RE: Florida Power & Light Company  
Riviera Beach Energy Center – Discharge Circulating Water Outfall Pipes  
Post-Certification Amendment (PA 09-54D)

|  | —              | 5          | DISCHARGE CIRCULATING WATER<br>12" DIA OUTFALL PIPES<br>MODIFICATION |     |
|  | RBEC-616257    |            | 1 OF 4                                                               | 0   |

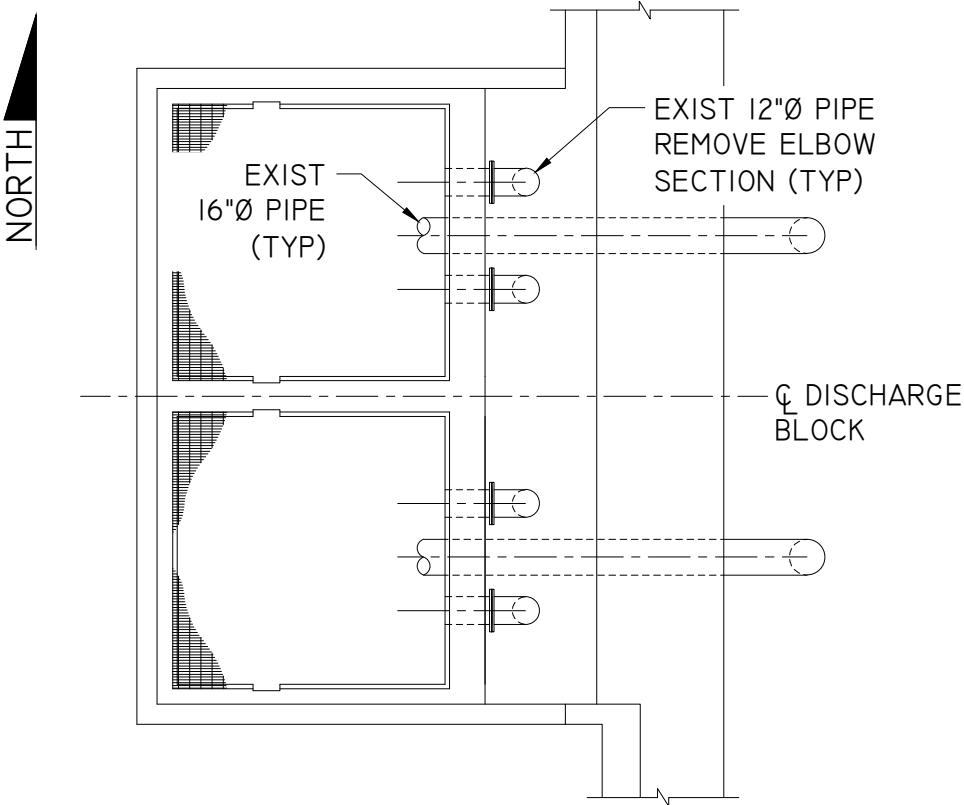
Florida Power & Light Company (FPL) is requesting a post-certification amendment to the Site Certification for FPL's Riviera Beach Energy Center, pursuant to rule 62-17.205(1)(A) F.A.C. The purpose of this amendment is to obtain approval to extend the current discharge overflow structure pipe directly into the manatee lagoon area which will be in line with the existing 16-inch pipes. The site location and location of the discharge pipes can be found in Attachment A. Activities will consist of extending the 12-inch diameter pipes along the existing structure which will be inserted about 4-feet into the lagoon area. The pipes will be capped at the ends and will include 4x6" perforated holes near the end of the pipes for water to exit into the lagoon as indicated in Attachment B. The purpose of this work is to direct overflow water into the lagoon versus splashing onto the discharge structure as shown in Attachment C. No in-water work is proposed and there will be no change of water temperature or sediment displacement because of this work.
